CONSTRUCTION SUMMARY

The Villages in Stayner - Zancor Homes (Stayner) Limited

| LOT / PHASE | HOUSE TYPE | PRINT DATE |
| 34 / 2 | <i>5001 (A)</i> | 17-Oct-18 |

BASEMENT
ELEVATION A

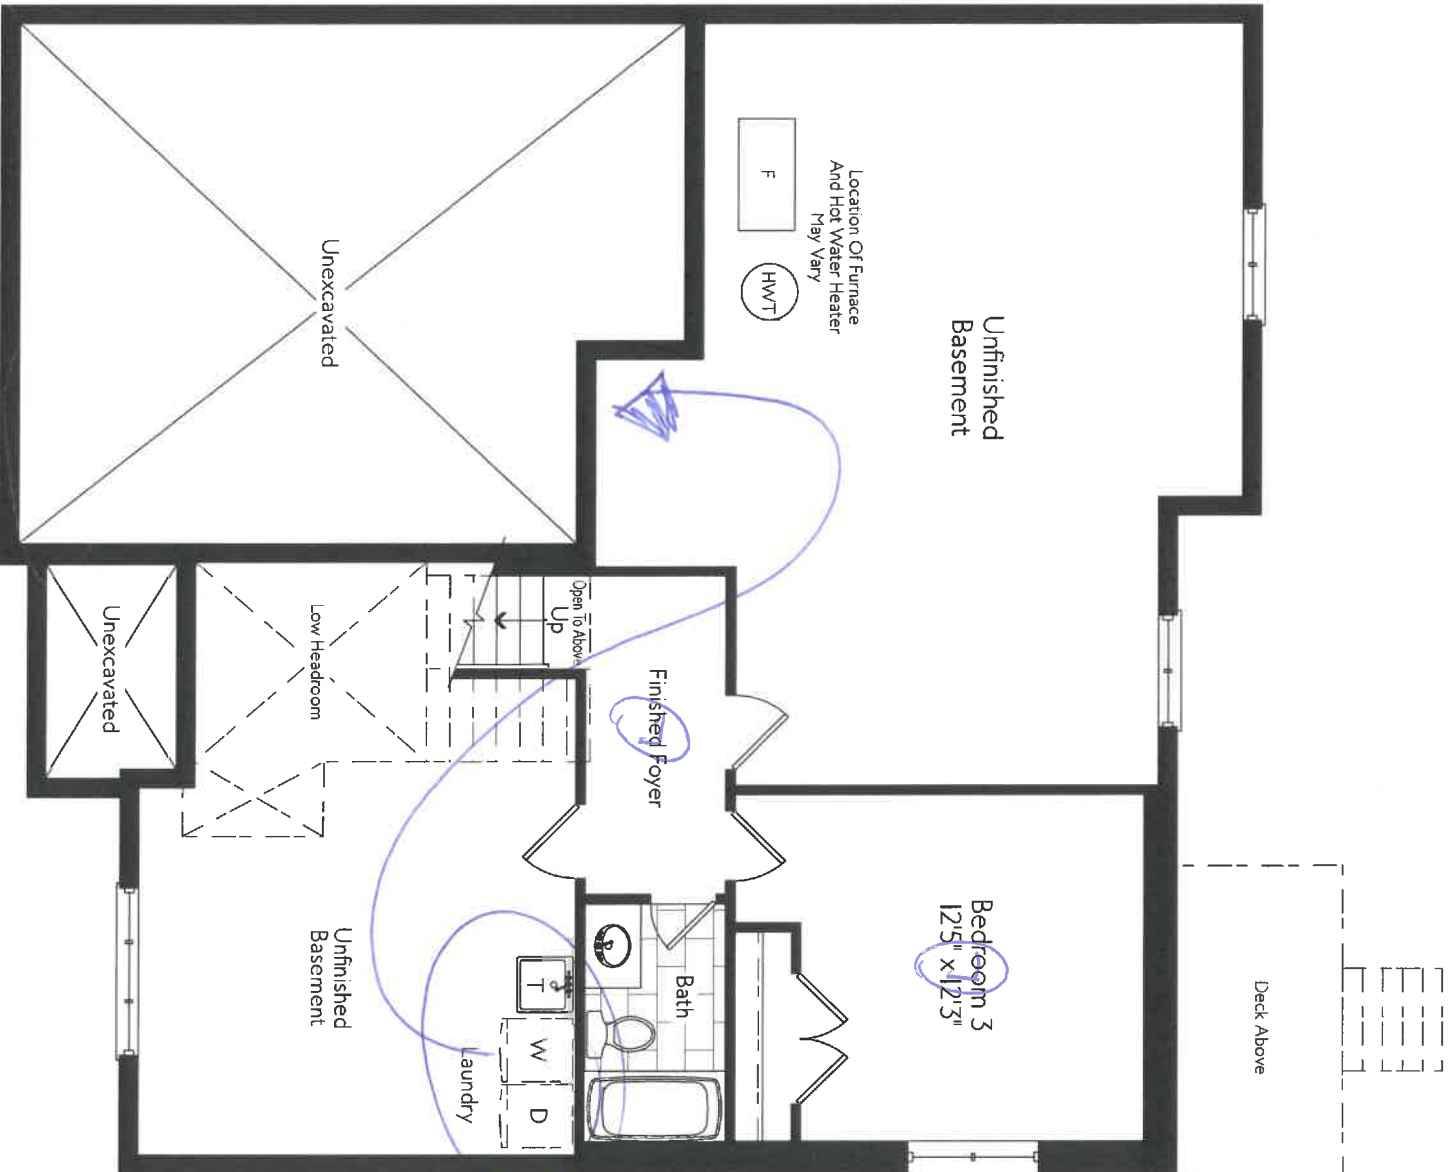
let 3rd
stay

OK

*Lot 34
Stayner*

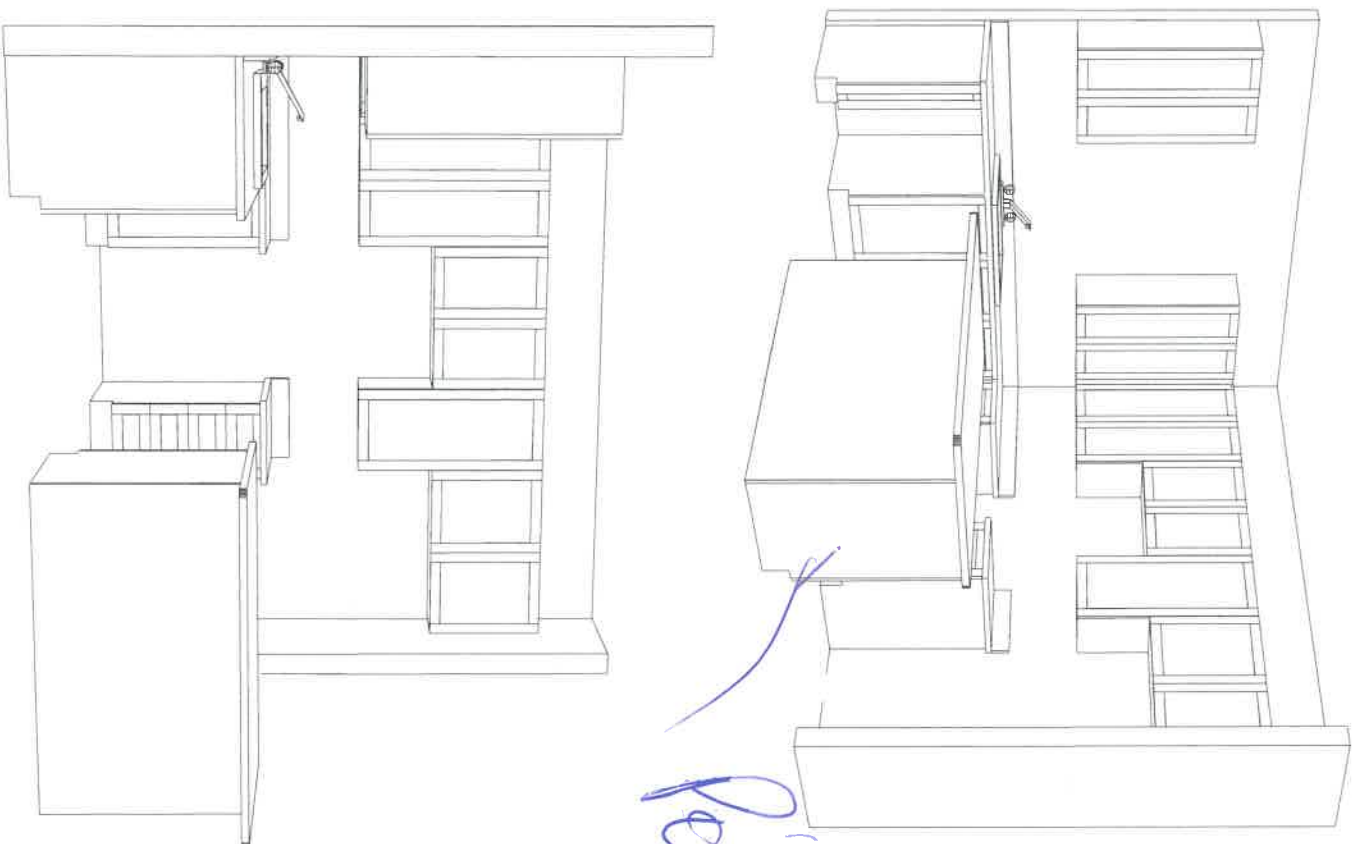
Ref. Drawers

On

for
